Re: Electric Substation Audit of PG&E Martin Headquarters (HQ)

SA2025-1313: PG&E Substation Audit, Martin HQ, May 19-23, 2025

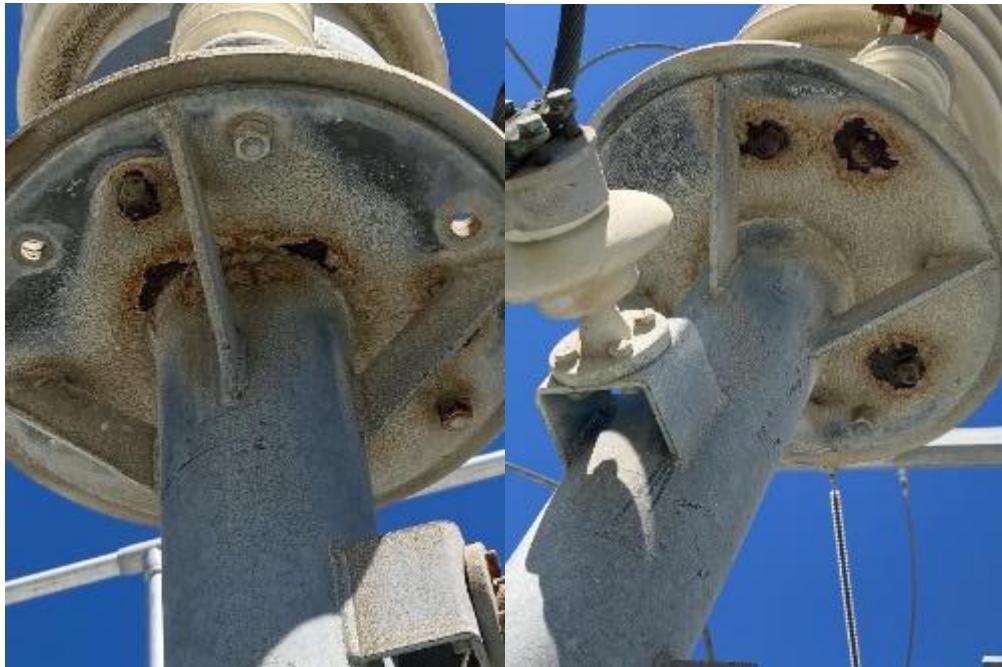
1.2. Switch 2341 closed semaphore is faded.

While we remain committed to maintaining equipment in a condition that promotes safety and adequacy of service, we believe this finding does not reflect a material deficiency under GO 174, Rule 12 because it allows for design and maintenance practices based on local conditions and accepted operational procedures. The semaphore in question is not used to verify switch position. Rather, switchmen confirm the position through direct observation of the switch mechanism itself.

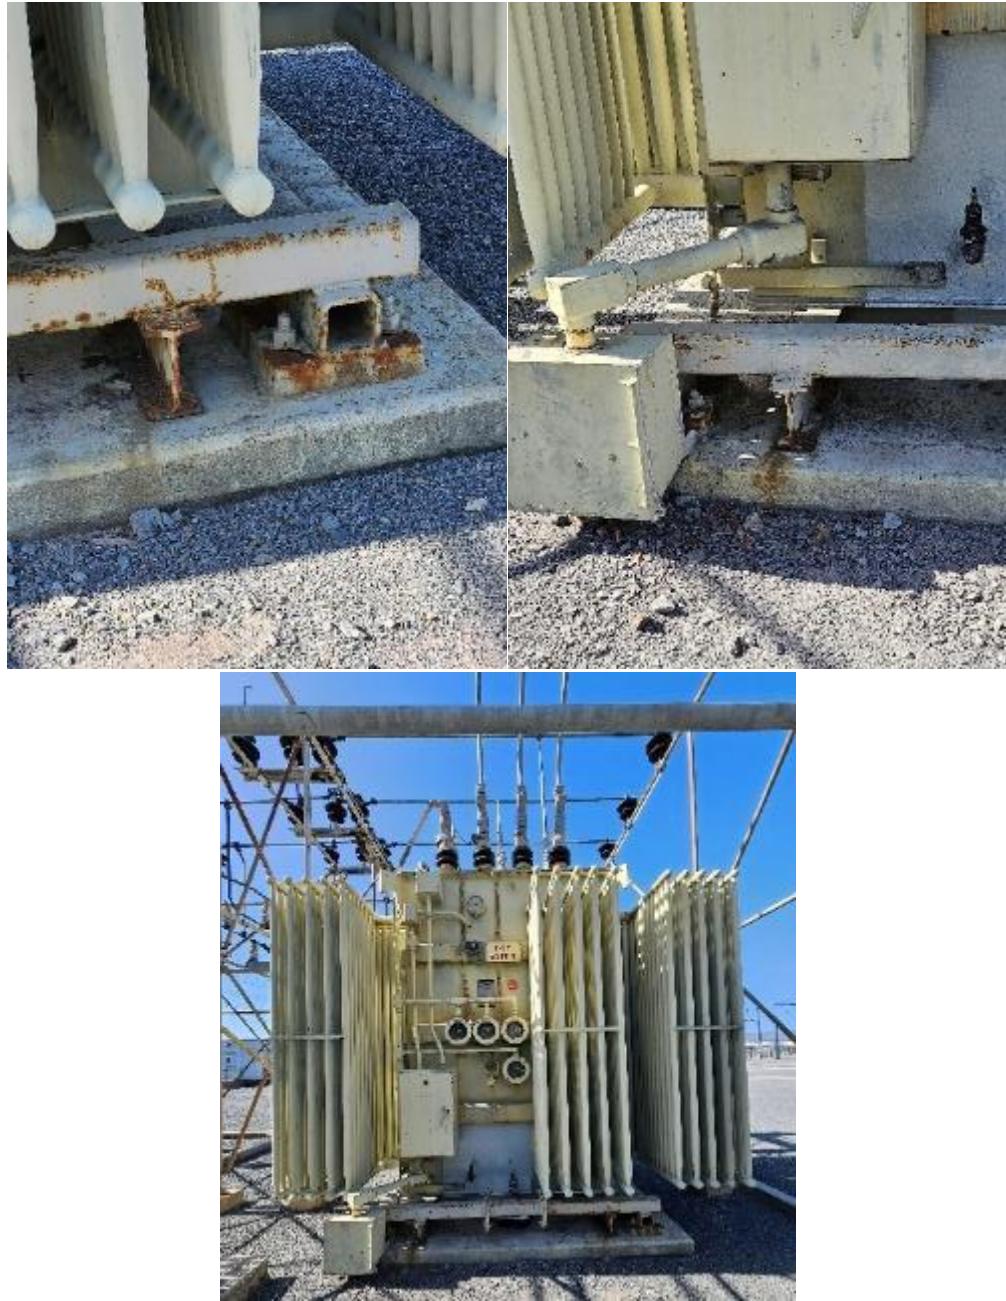
2.1. CB 1114/2 has a faded counter. PG&E has an open LC 130774717 to replace the counter.

Pre-existing LC notification 130774717 was established in our system of record, SAP, prior to the field audit to address faded counter located in circuit breaker 1114/2 at East Grand Substation. This LC notification is being worked in accordance with our maintenance. The notification is being actively managed in accordance with our maintenance procedures and is not past due. Therefore, this finding does not qualify as a violation of GO 174, Rule 12.

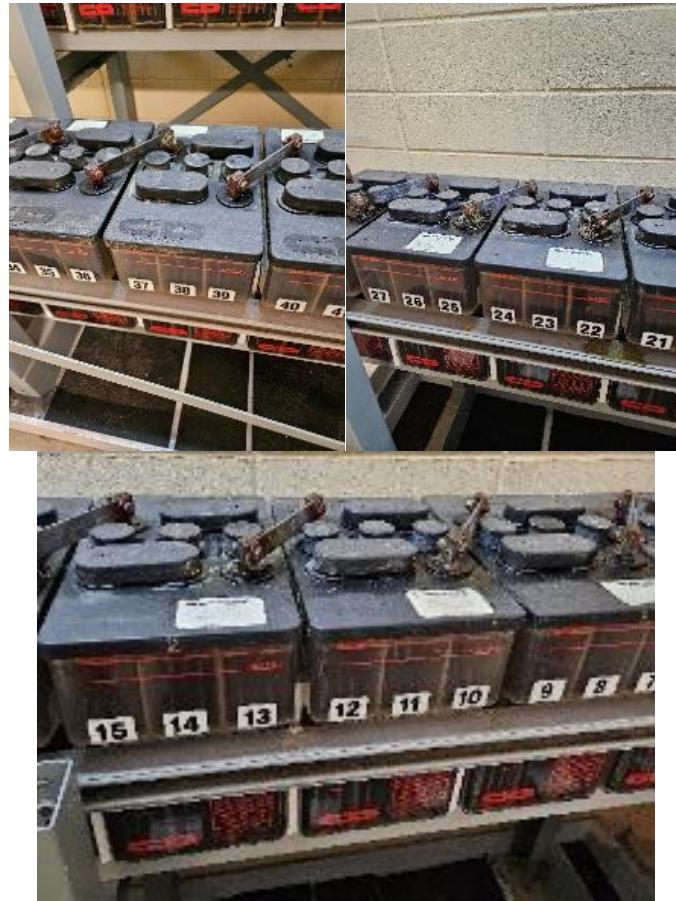
4.3. Bird nest at low side insulator bushing of Bank 1.

We created LC Notification 131419589 to address ESRB's finding regarding the bird's nest, added it to our work plan, and completed it on September 15, 2025.

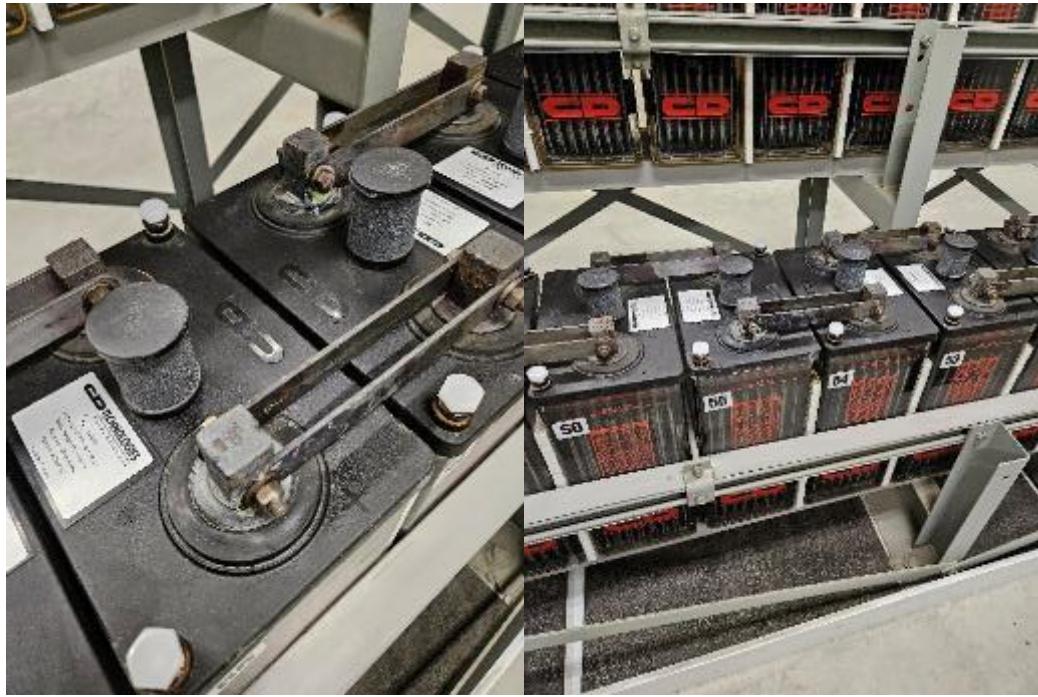
18.9. Faded counters at CB A-1114/2 and CB A1117/2. PG&E has an open LC 128457081 to replace the counters.

Pre-existing LC Notification 128457081 was established in our system of record, SAP, prior to the field audit to address the faded counters at CB A-1114/2 and CB A1117/2 at San Francisco A (Potrero) Substation. We disagree that this finding qualifies as a violation of GO 174, Rule 12 since this LC notification was worked in accordance with our maintenance procedures and completed on July 19, 2025.
